Product Change Notice (PCN)

PCN Number: PCN-0451205R-01

Product(s) Affected: PJ-057BH

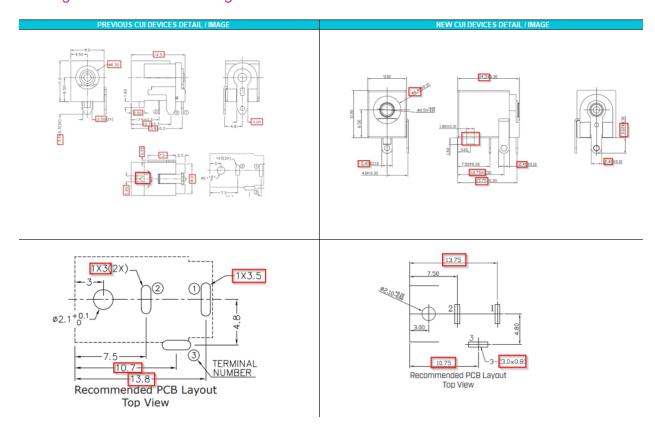
Description of Change: Minor Housing and footprint differences. Material Change on the housing and terminals. See image Below

PREVIOUS C	UI DEVICES DETAIL / IN	NAGE
	MATERIAL	PLATING
center pin	copper	nickel
terminal 1	brass	silver
terminal 2	copper alloy	silver
terminal 3	brass	silver
plastic	PBT

DESCRIPTION	MATERIAL	PLATING/COLOR
center pin	brass	nickel
terminal 1	brass t=0.40	silver
terminal 2	bronze t=0.30	silver
terminal 3	brass t=0.40	silver
cover	PA10T (UL94V-0)	black
housing	PA10T (UL94V-0)	black
